PLANT NAME: Robinson #2

Serial: NG-76-155

H. B. ROBINSON UNIT NO. 2  
DOCKET NO. 50-261  
LICENSE NO. DPR-23  
INTEGRITY OF SWING-CHECK MSIV'S

Figure 1. Modified Tail Link-Side View

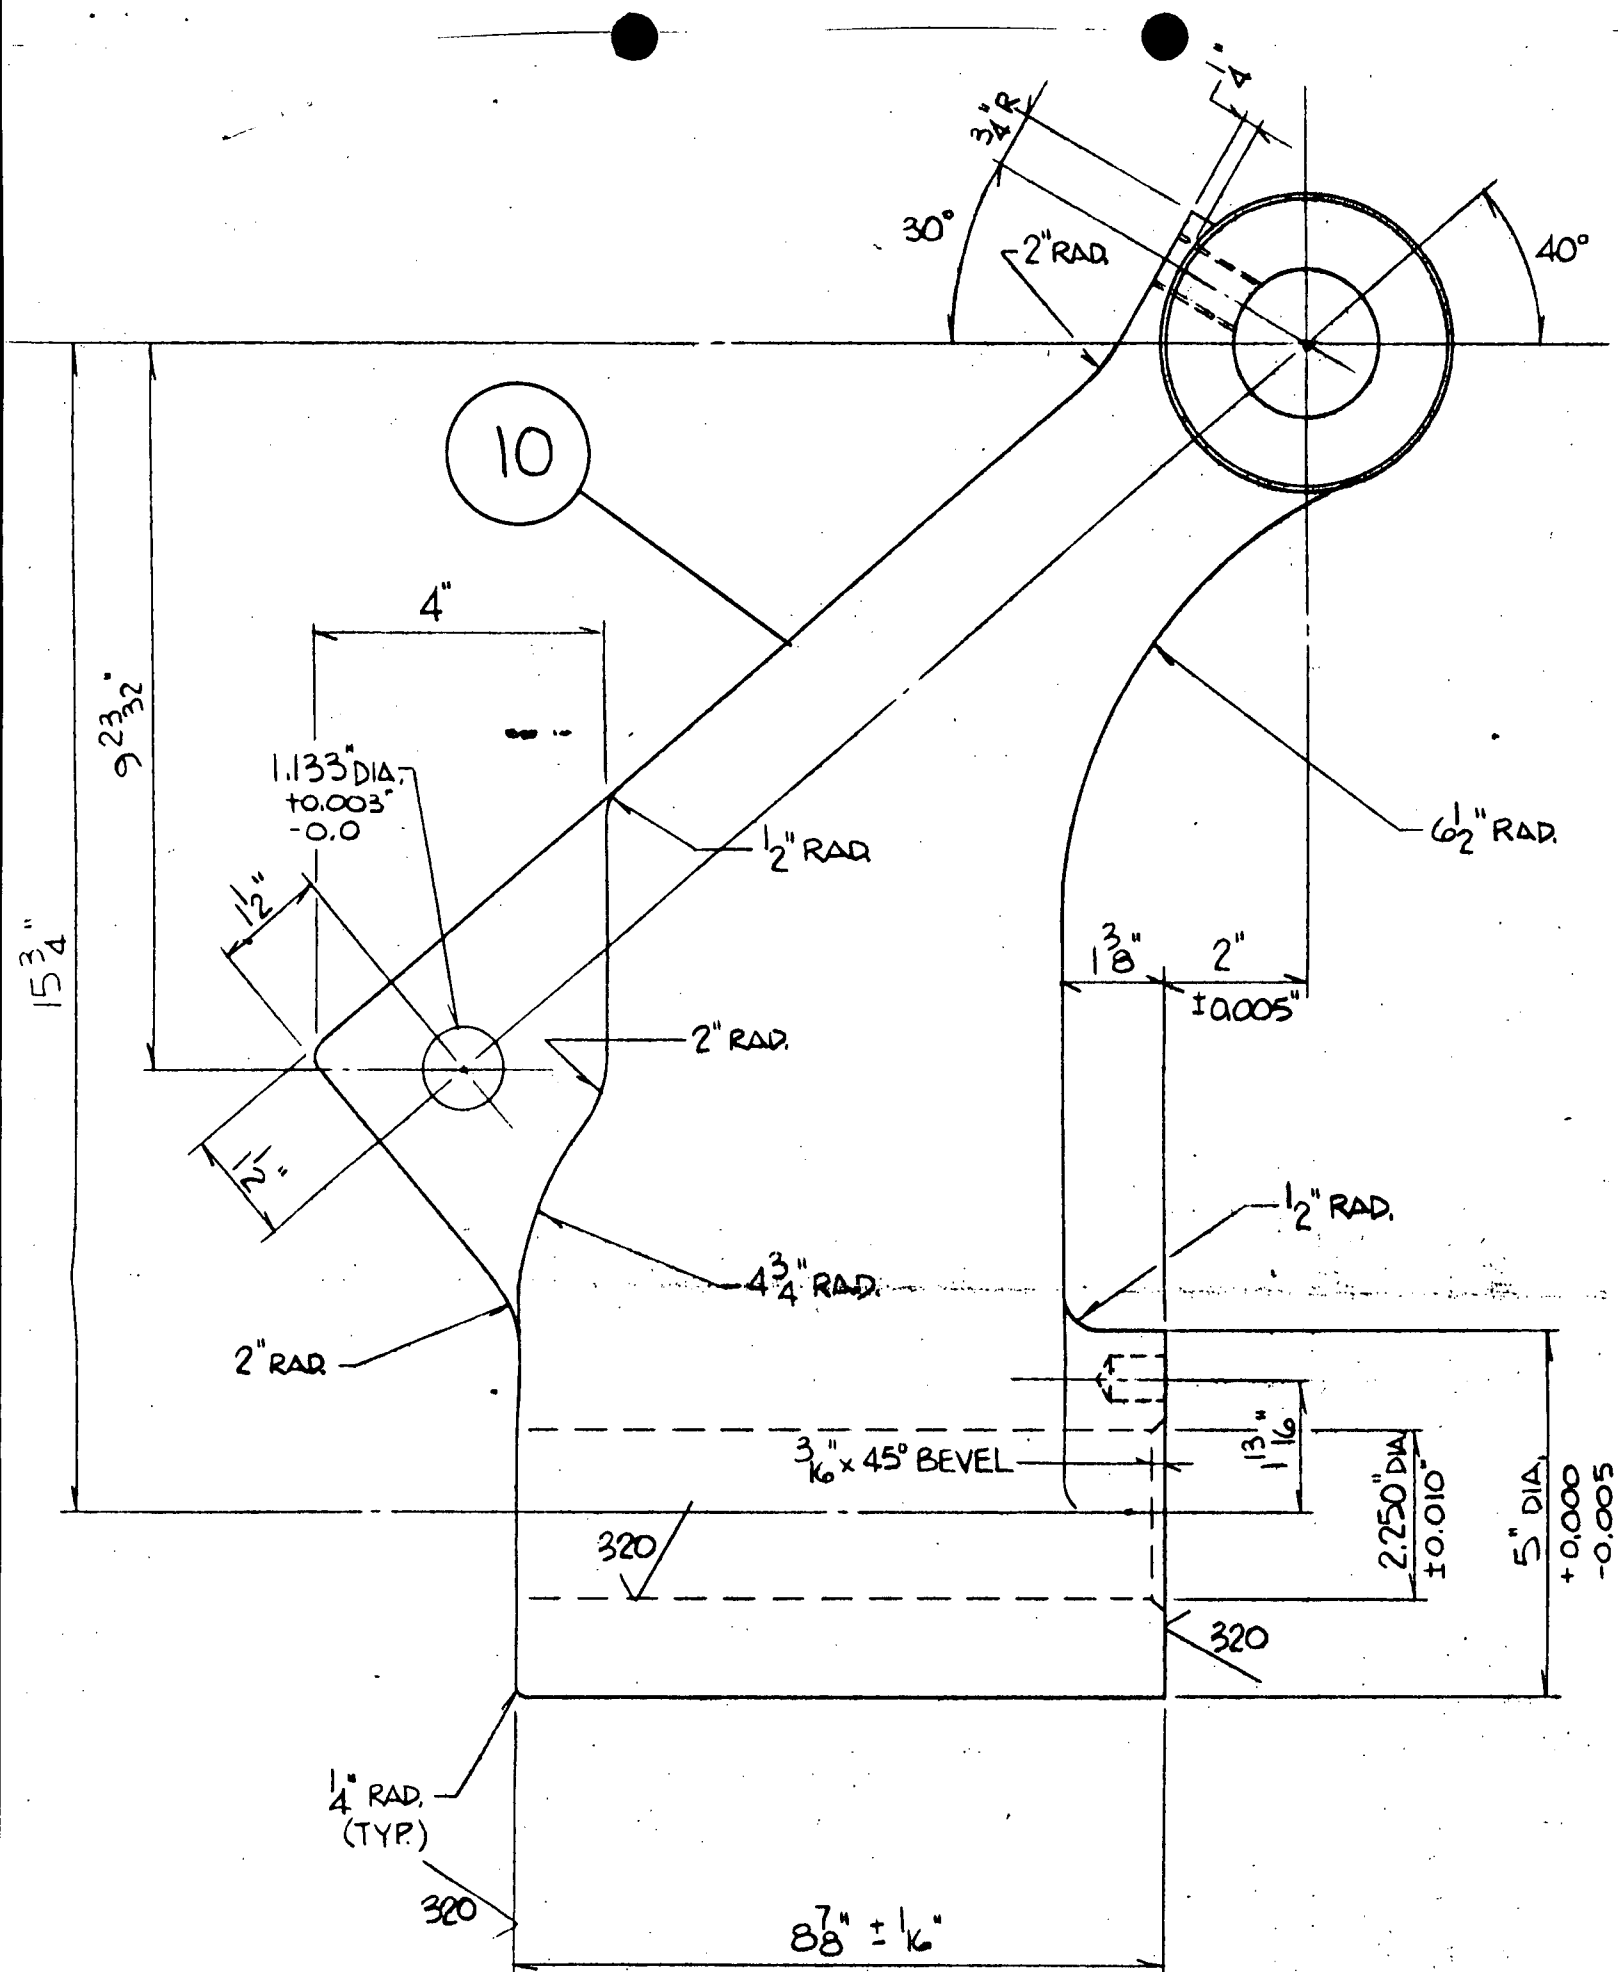
- a) The rockshaft will be replaced with a rockshaft of larger diameter (2.162 in. vs. 1.625 in.) and of different material with stronger physical properties. A larger diameter bushing will also be added.
- b) The tail link will be reinforced to improve its resistance to bending in the hub area (Figures 1 and 2). This is accomplished by adding material to the section between the tail link sleeve and tail link hub as well as increasing the length of the hub.
- c) A stainless steel seat ring will be welded to the existing valve seat (Figure 3).
- d) The disc will have an increased stainless steel weld overlay added to the area that impacts the valve seat upon closure. The disc will be recessed and tapered to allow the tail link hub to penetrate the disc (Figure 4).
